Fiat Scudo 1.6D Multijet 90

**Year of manufacture: from 2007 until VIN →
84160387**

Poor air conditioning system performance

Bulletin

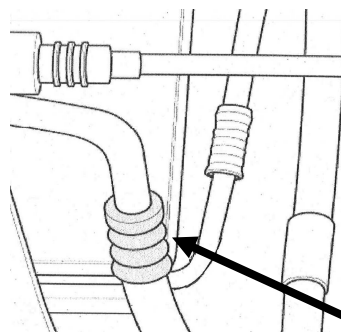
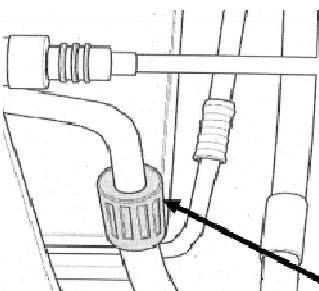
If the vehicles mentioned above experience poor air conditioning performance or a loss of coolant, the possibility of a coolant leakage between the condenser and compressor must be considered.

Check the coolant line for the correct model type and replace if necessary. (see figures)

- Old model types -

This is the modified model type from the vehicle manufacturer: [Spare parts]

- 1 unit: Coolant line: (Spare parts): 140142280
- 2 units: O-ring: (Spare parts): 9645950980

- New model type -
